## DRAINAGE AND TRANSPORTATION INFORMATION SHEET

**RE: Revised Grading Plan (F11-1D014G  
Lot 32P1 Oxbow bluff  
Albuquerque, New Mexico**

ENGINEER'S SEAL  1/14/15 DAVID SOULE P.E. #14522	LOT 32-P1 OXBOW BLUFF SUBDIVISION	DRAWN BY JDG
	GRADING AND DRAINAGE PLAN	DATE 01-13-2015
 Rio Grande Engineering 1606 CENTRAL AVENUE SE SUITE 201 ALBUQUERQUE, NM 87106 (505) 872-0999	SHEET # 1 OF 1	JOB #

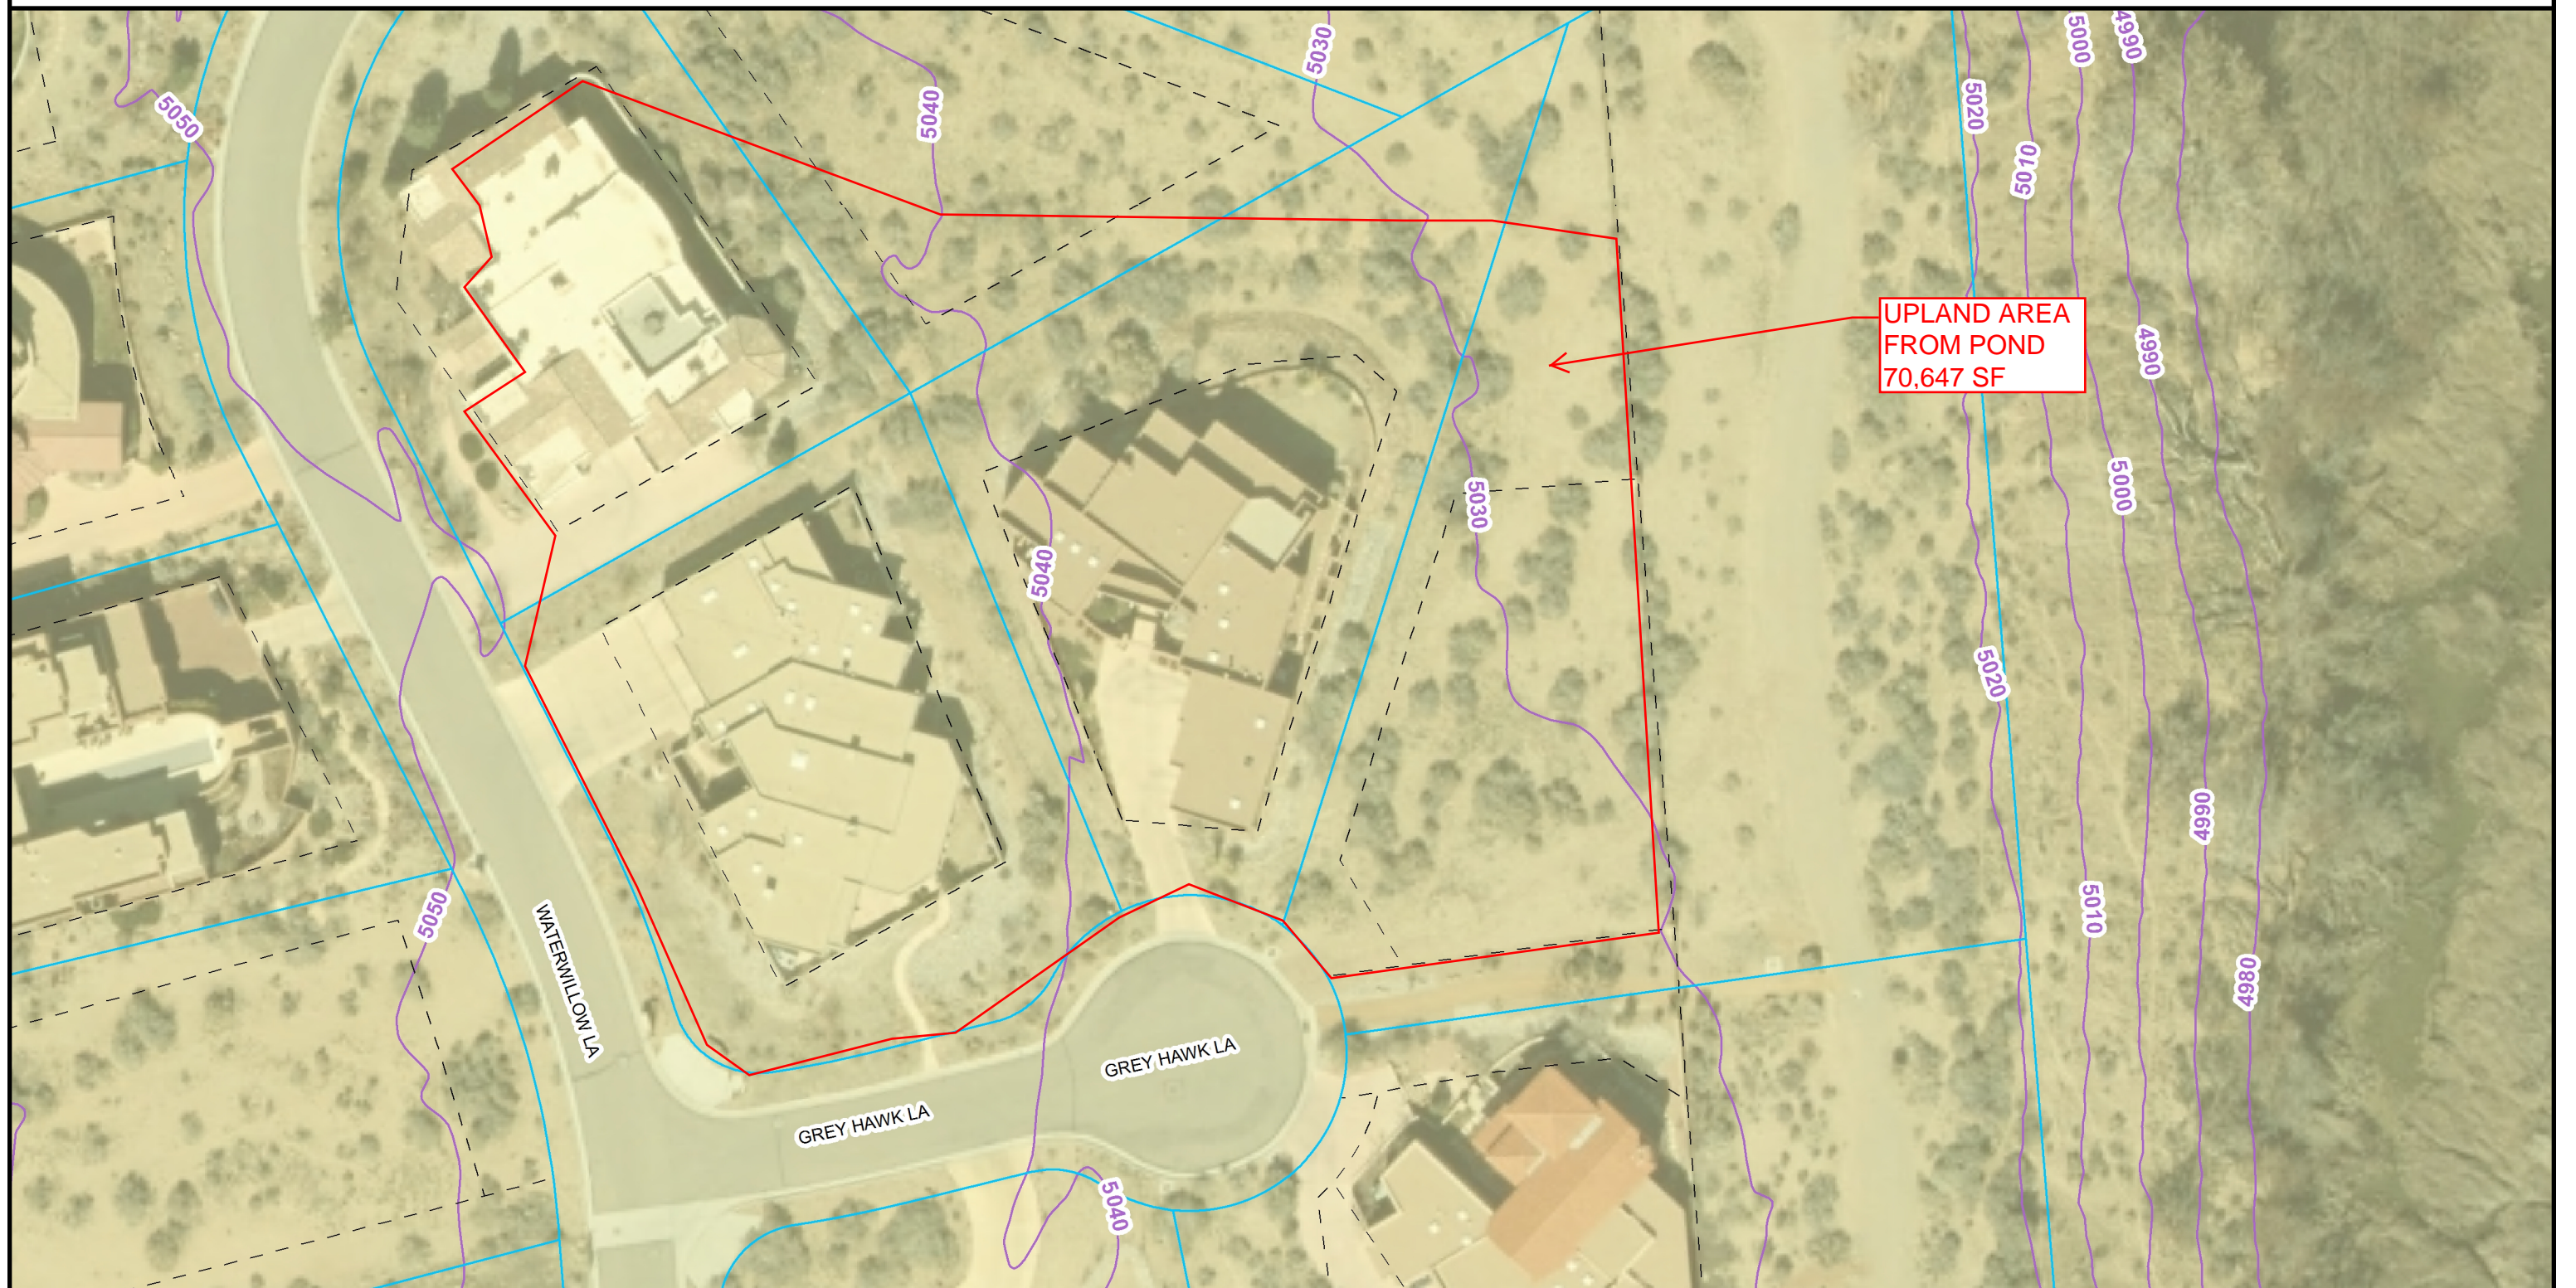
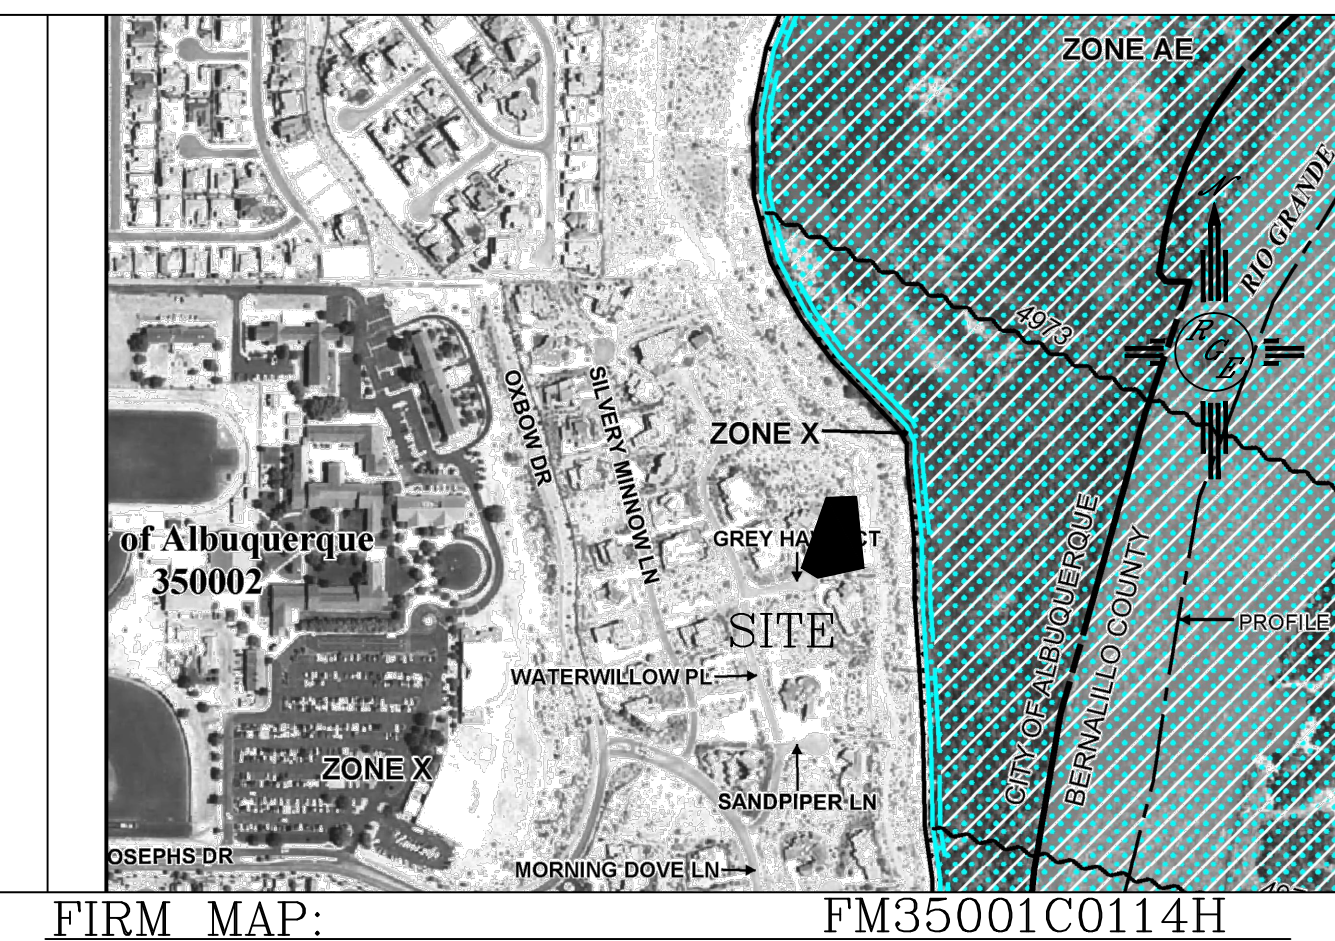
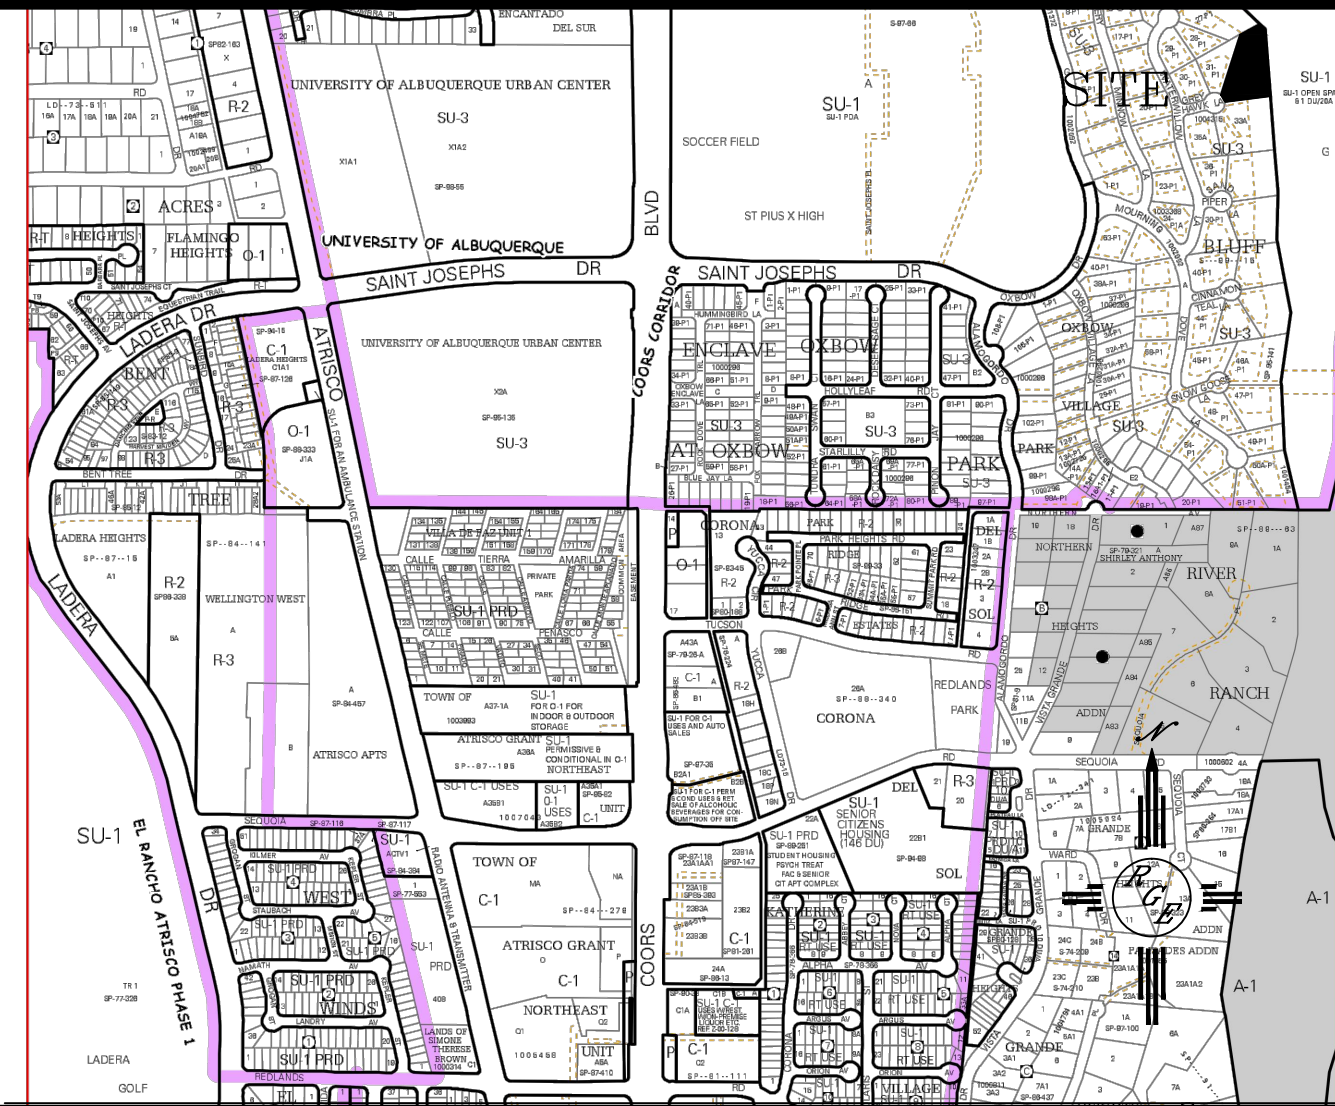
1. Show Mwsel, overflow and contours on pond  
**We have added the overflow and contours. Since the pond is a water quality pond only the water surface elevation will be the spillway. The entire contributing basin generate a peak of 4.1 cfs, the spill way has a capacity for 20.8 cfs. We have shown the entire lot that shows the existing inlet outfall**

2. Provide drainage narrative.  
**We have added the narrative the plan**
3. Provide benchmark  
**We have added the benchmark.**
4. Show property liners.

7. Show roof drains and flow directions  
**We have added**
8. How is offsite handled  
**We have included a basin map for the contributing area. The city AGIS map with 2' contours was utilized but the website will not allow print outs. So the County GIS was used to show. The flow is allowed onto the site and drains through the first flush pond, the overflow has capacity for entire upland flow to safely pass.**

9. Were is public drainage easement  
**We have shown entire property including referenced easement.**

10. Where is oxbow main outfall?

11. Show flow arrows and contours

**We have shown property line .**
5. Don't show architectural features  
**We have removed**
6. Provide relevant information from the master drainage plan

**The narrative includes the reference to the Oxbow master drainage plan(G11D14). This site is located within basin F and allowed to discharge based upon 58%A and 42%D..**

**We have shown the inlet we are draining to on the plan set**

**We have added the contours for the plan**
